UNITED STATES PATENT AND TRADEMARK OFFICE

10/692,442

Office Action Summary	Application No. 10/692,442	Applicant(s) WHITTAKER ET AL.	
	Examiner William V. Gilbert	Art Unit 3635

DETAILED ACTION

Figure 9 from Christy

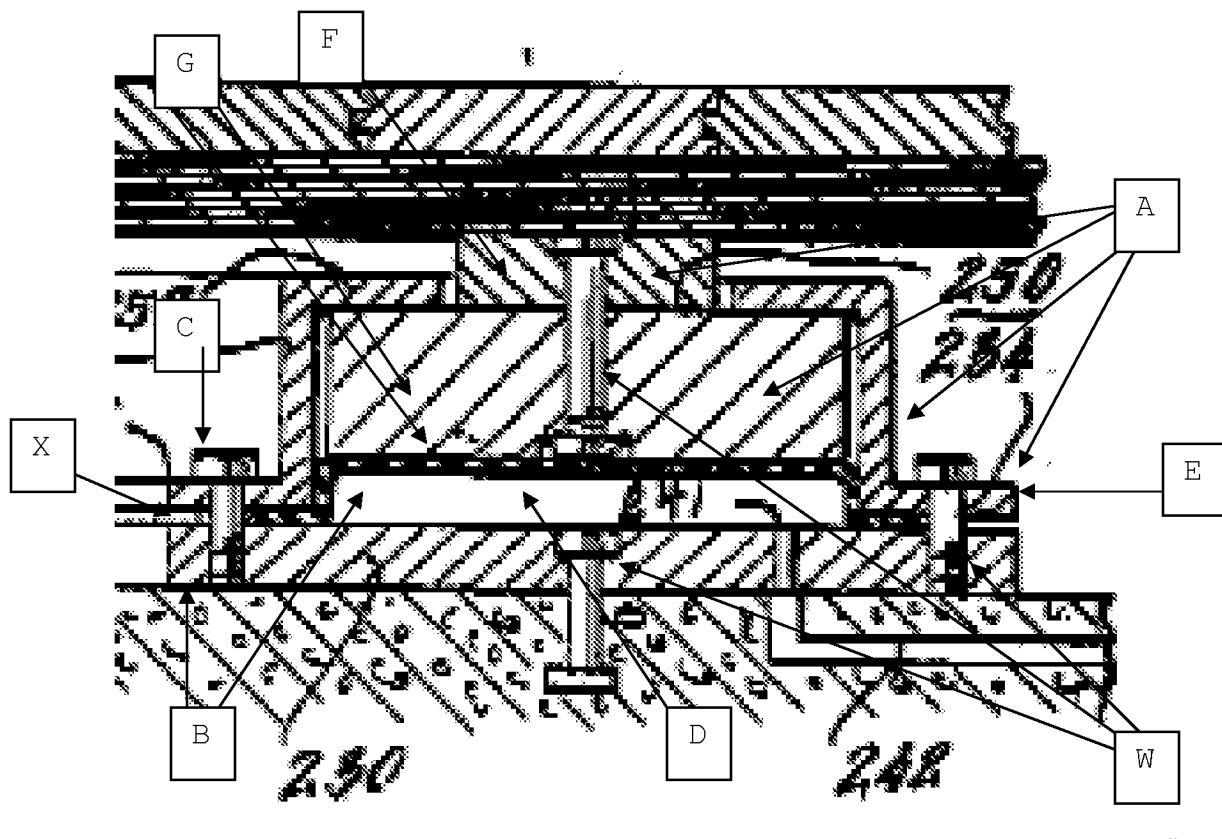
Claim 1: Christy discloses an apparatus for isolating and leveling a machine foundation with respect to a substructure comprising a rigid enclosure (Fig. 9) having a substantially hollow upper portion (see "A" from attached Fig. 9, below, the spacers show that it is substantially hollow) telescopically adjustably connected to a substantially hollow lower portion ("B" below) to provide for various sizes of the enclosure,, means for rigidly connecting the upper portion of the enclosure to the lower portion ("C" below) for fixing the position of the

upper portion with the lower portion and means for providing leveling adjustment ("D" below; the inflatable portion) of the foundation.

Claim 2: the upper portion has a flange ("E" above) having an aperture extending therethrough (the bolt is in the aperture) and the lower portion has an anchor ring (230; see Fig. 9, generally where it is ring-shaped; see Fig. 5) with at least one

rod (the bolt, "C" above) connected thereto and extending through the aperture in the flange above the upper portion, and a slip joint (the connection between the upper and lower sections is a slip joint) connected to the flange of the upper portion for releasably connecting the rod to the flange.

Claim 3: the lower portion has an anchor ring (230; see Fig. 9, generally where as shown this is a ring-shaped device, the upper surface extends into the interior as it is a part of the interior; see also Fig. 5) a bearing member ("F" above) within the enclosure and adjustable connecting to the anchor ring (via the leveling means) to provide a leveling adjustment of the foundation, and a support member ("G" above, including inflatable portion) in contact with the bearing member and engageable with the substructure. The two members "engage" via the lower portion.

Claim 9: Christy discloses an apparatus for isolation and leveling comprising a rigid enclosure connectable to the machine foundation having a substantially hollow upper portion ("A" above) and a substantially hollow lower portion ("B" above) telescopically connected to one another, the lower portion

having an anchor ring (230) that extends into the interior of the enclosure (the upper surface of the ring extends into the enclosure,) a bearing member ("F" above) disposed within the enclosure above the anchor ring, a plurality of fasteners (see "W" above) that connect the bearing member to the anchor ring in a vertically spaced relationship (see Fig. 9) for vertical adjustment of the anchor with the bearing member (the members can be loosened or tightened as needed for adjustment,) and a support member ("G" above and leveling means) in contact with the bearing member and engageable with the substructure for isolating the machine foundation from the substructure.

Claim 21: the upper portion is tubular (it is in the shape of a ring, which is tubular) and having open ends (there is an open end on each side of the bearing member), the lower portion is substantially tubular (it is in the shape of a ring) and having open ends (see "X" above; the joints between the upper and lower portion on each side is an open end.)

Claim 24: the anchor ring has an inner perimeter (proximate "X") and the fasteners ("C" above) are arrayed around the anchor ring adjacent the inner perimeter.

The examiner respectfully disagrees with applicant's argument that the upper and lower enclosure portions of Cristy (cited above) are not adjustably connected to one another. The examiner notes applicant's exhibit A and notes that this is what the examiner considered the upper and lower portions, respectively, however, a portion of "A" including portion 250 will telescopically adjust with respect to the inflation or deflation of portion "D" above. Further, depending on the level of inflation of portion "D" above, the enclosure can vary in size.

case, the rejections were made as a matter of anticipation, and the examiner maintains that the prior art of record anticipates the limitations as claimed. Regarding applicant's discussion of "a rigid enclosure", the examiner maintains that the connection is rigid (Fig. 9: portion 240 is rigidly connected to member 230 via the attachment members).

The examiner respectfully disagrees with applicant's assumption that replacing member 232 with member 172 would result in a structure that is no longer hollow. The examiner respectfully disagrees in that the inflated portion would result in a substantially hollow member. Just as portion indicated as "D" aids in defining the hollow member, the air bag would equally define an open, or hollow space, when inflated.
